City of  
Richmond

## Report to Development Permit Panel

**File:** DP 18-829207

**Re:** **Application by Arcadis Architects (Canada) Inc. for a Development Permit at  
9520 Beckwith Road**

**A0.09**

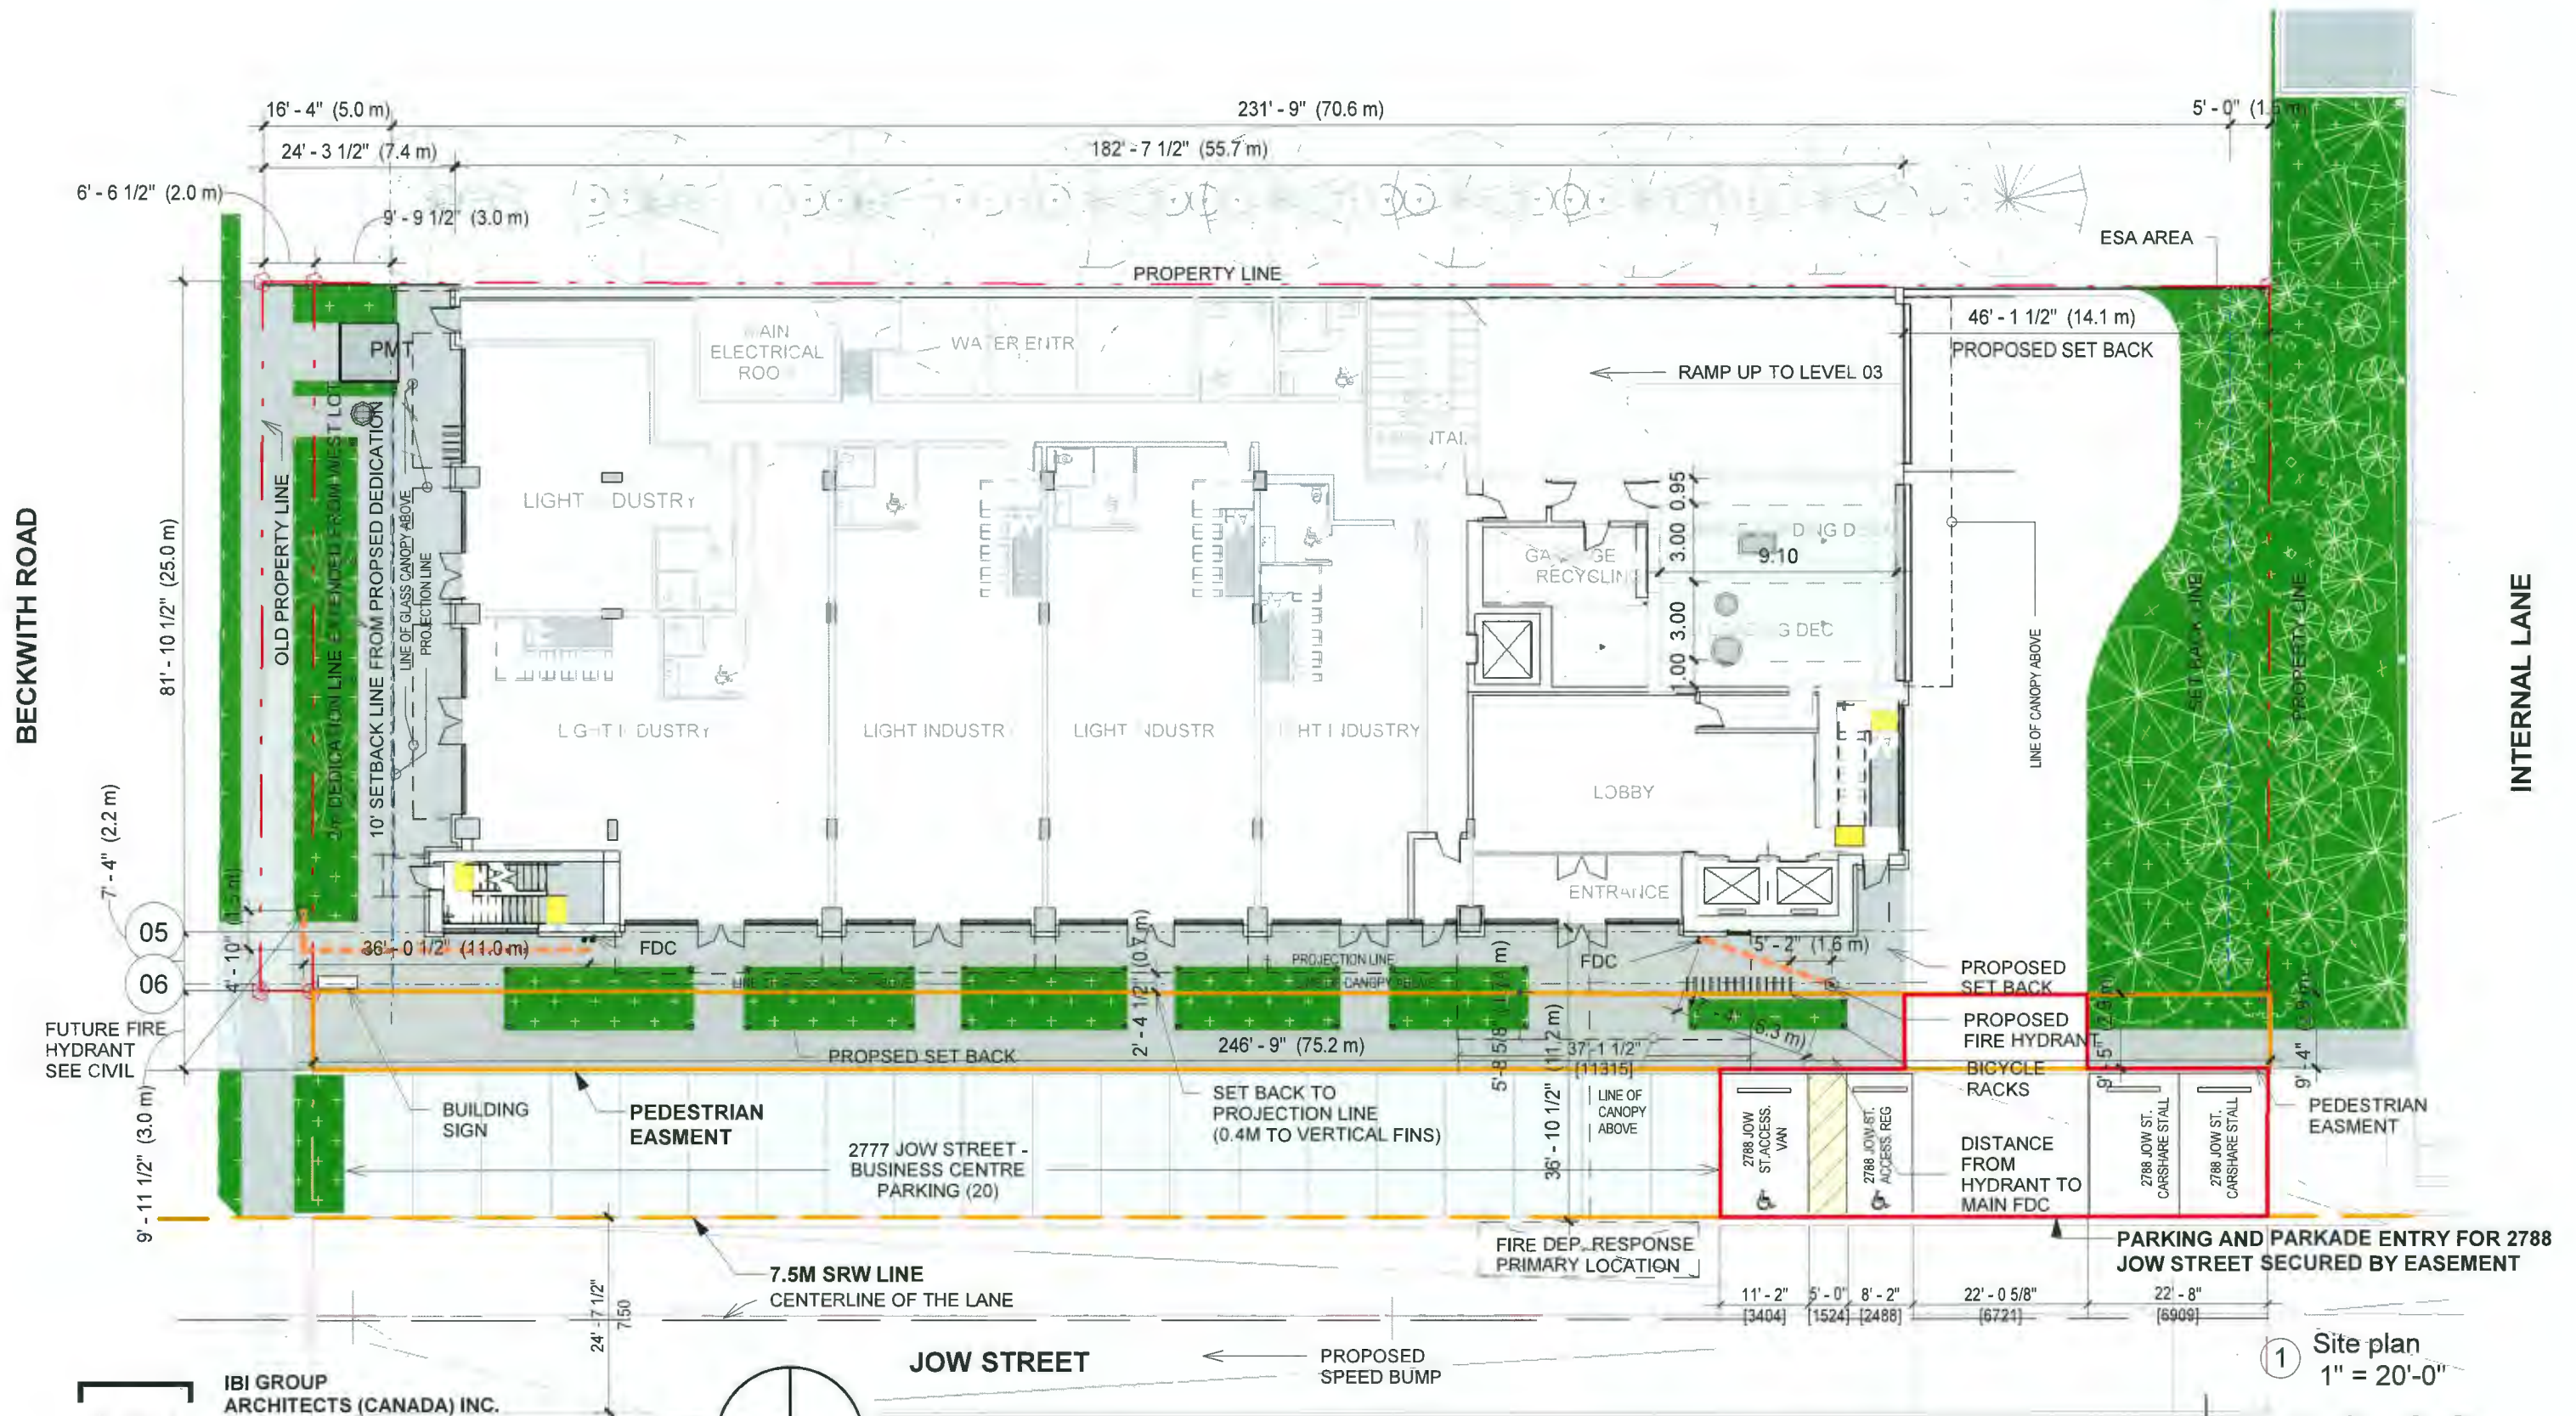
- appreciate the high density of tree planting and landscaping along the building's Beckwith Road frontage to provide a buffer to the existing single-family homes to the north; however, consider opening up the landscaped area along the north edge of the site to provide additional pedestrian access to the building from the north and address potential CPTED concerns; ***IBI: Landscaping at North elevation, along Beckwith road, was revised accordingly, to open up the elevation and introduce additional pedestrian connection. See A0.09 and L-02A***

- support the proposed bollard lighting along the west and north sides of the building;
- consider introducing landscaping around the Pad Mounted Transformer (PMT) fronting Beckwith Road to screen it from pedestrian view; ***IBI: Green hedge was added around PMT, to create aesthetic concealment. See A0.09 and L-02A.***

- shadow study shows that the north elevation is a dark space most of the time; high density of planting including trees, native shrubs and planters along the Beckwith Road frontage will pose sightline issues; consider keeping the planting low and open up some of the trees to allow more sunlight; ***IBI: Landscaping at North elevation was revised accordingly, to allow more sunlight in. See A0.09 and L-02A***

## A1.05

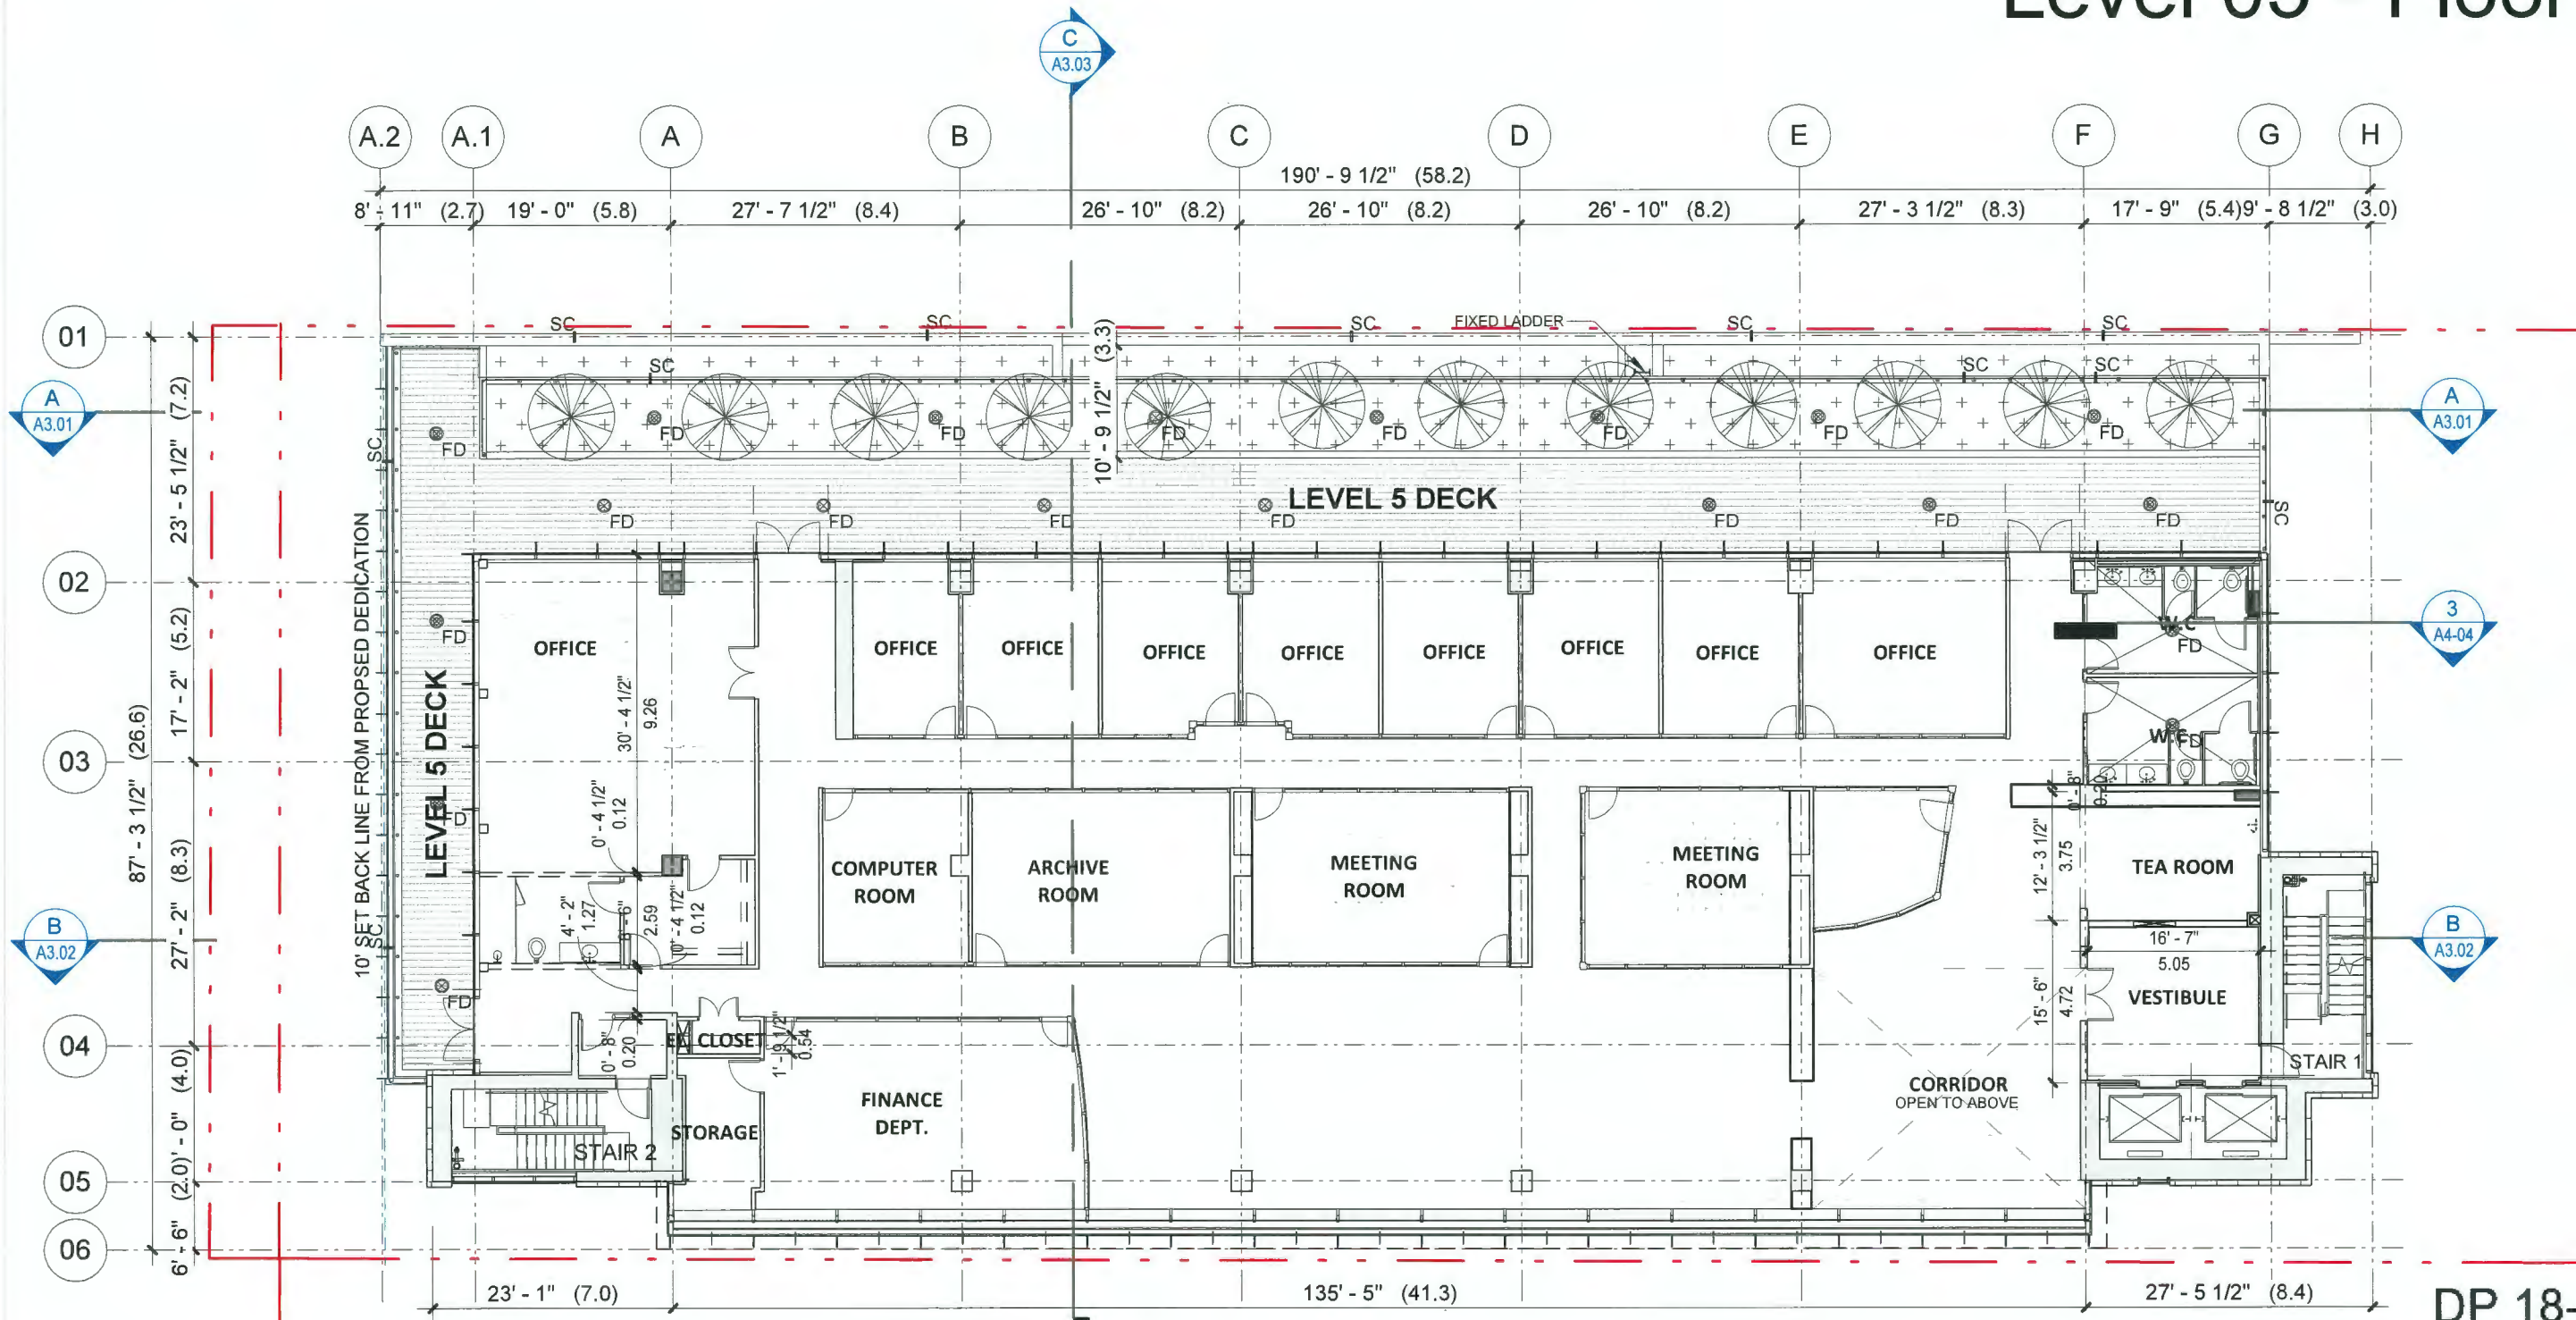
- support the Panel comment regarding the lack of provision for maintenance access for vines on the lower planter below Level 5; consider installing a permanent ladder structure on the outside to connect the higher Level 5 planter to the lower planter;

***IBI: Guardrail access will be provided to maintain step-down planter. A fixed ladder is shown on A1.05 (at Gridline L1 between Gridlines D/E).***
- programming on the building rooftop could be enhanced; consider breaking up the 20-foot long planting bed into smaller beds as it is difficult to maintain; the applicant could use the freed space for other uses that would benefit office space users; ***IBI: A break in the landscaping was made.***

Drawing Title: **SITE PLAN - LEVEL 1**  
 VIZ Project #: **DP2018-29**  
 Drawing #: **L-02A**

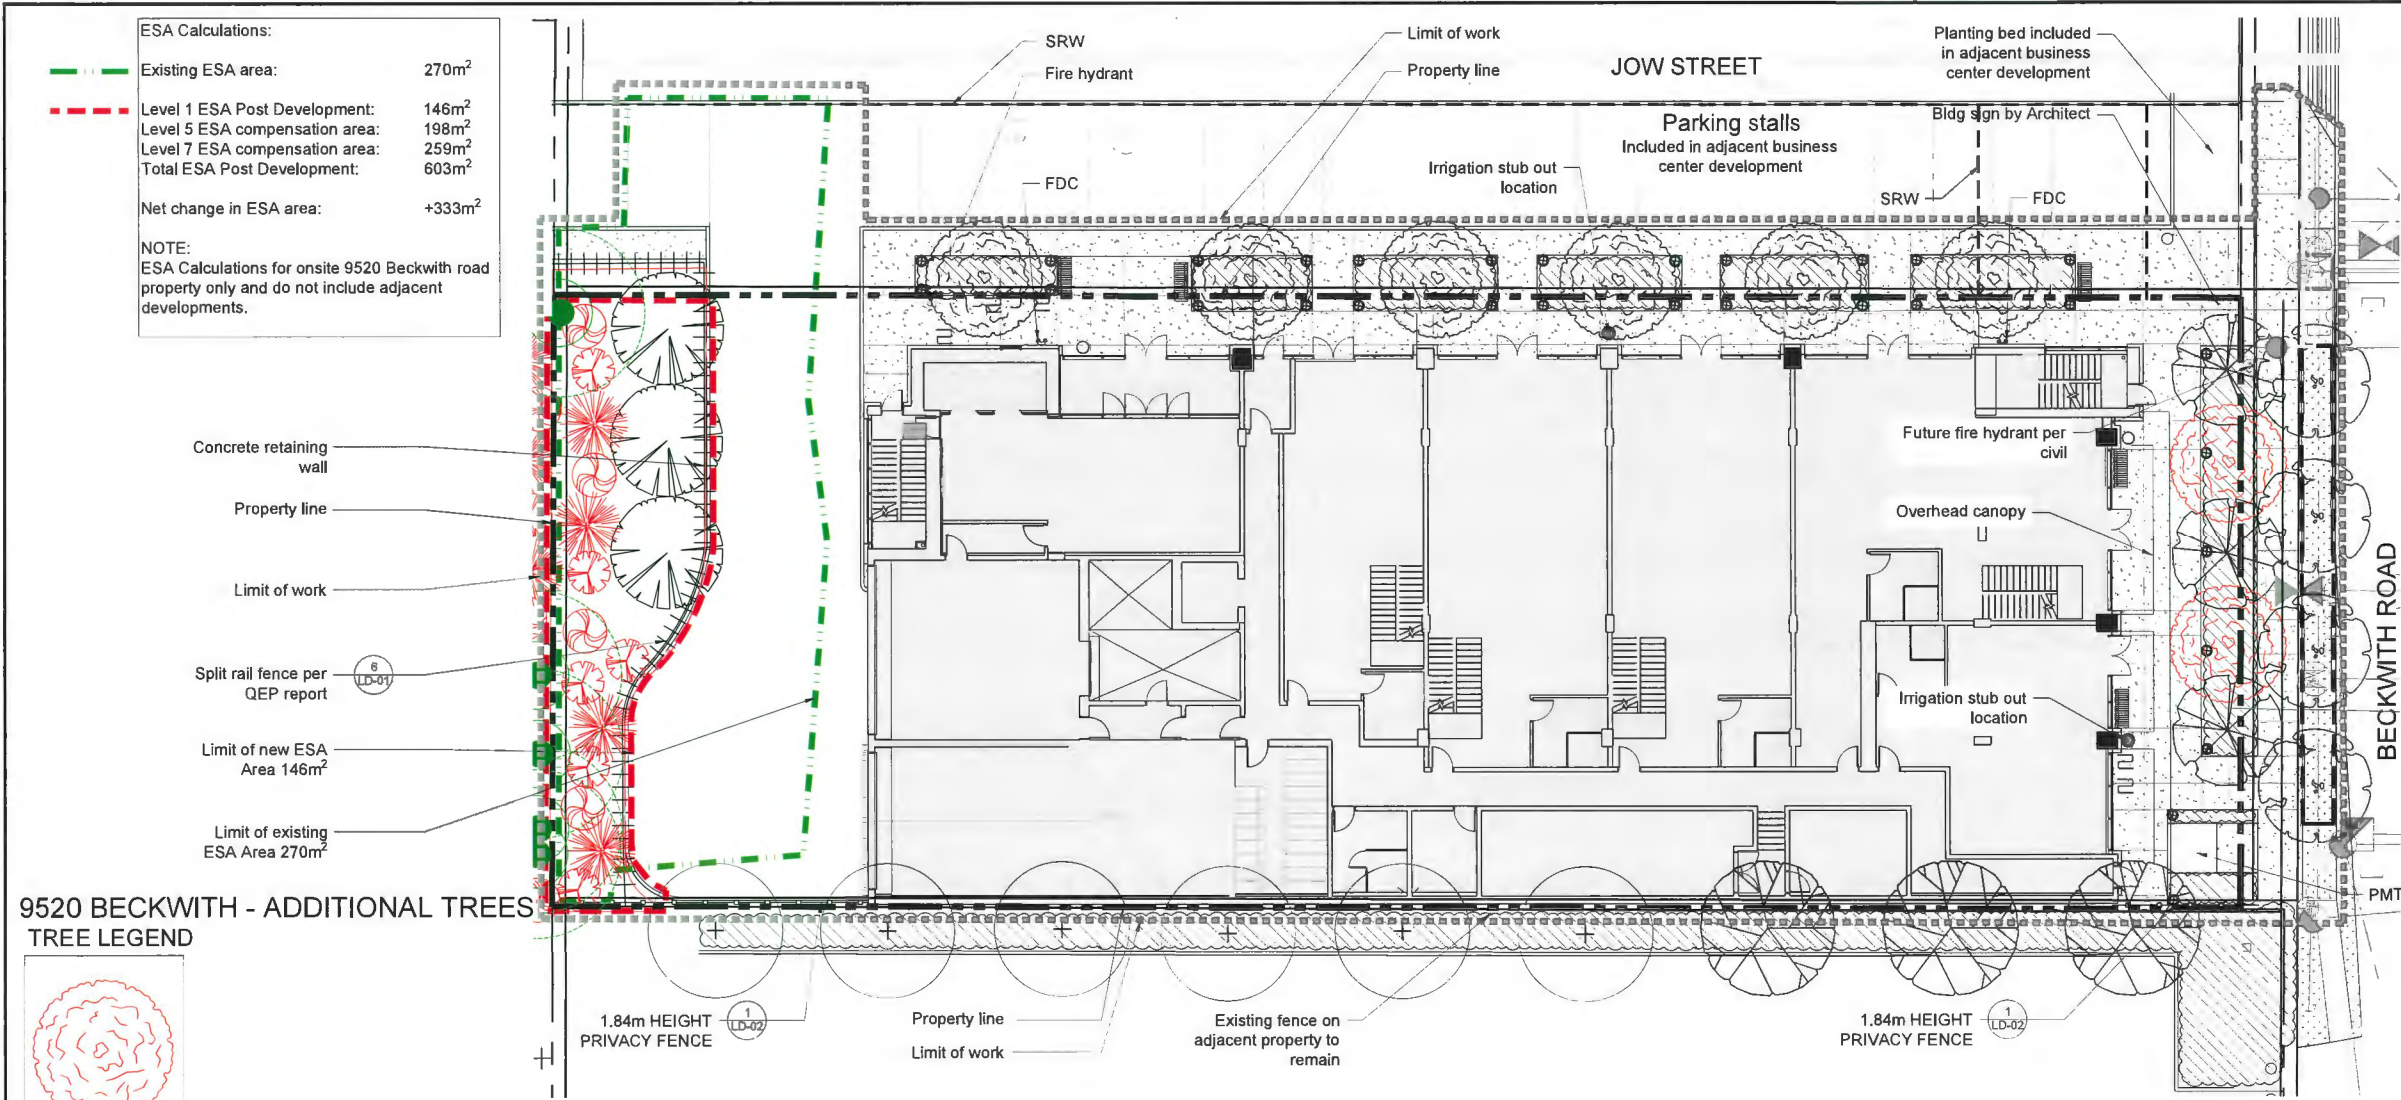
- consider adding lighting to the loading area on the south side of the building to enhance pedestrian experience and safety at night; ***IBI: Upward accent lights and flood lights were added to increase illumination, accentuate the trees, along South elevation. See L-02A.***
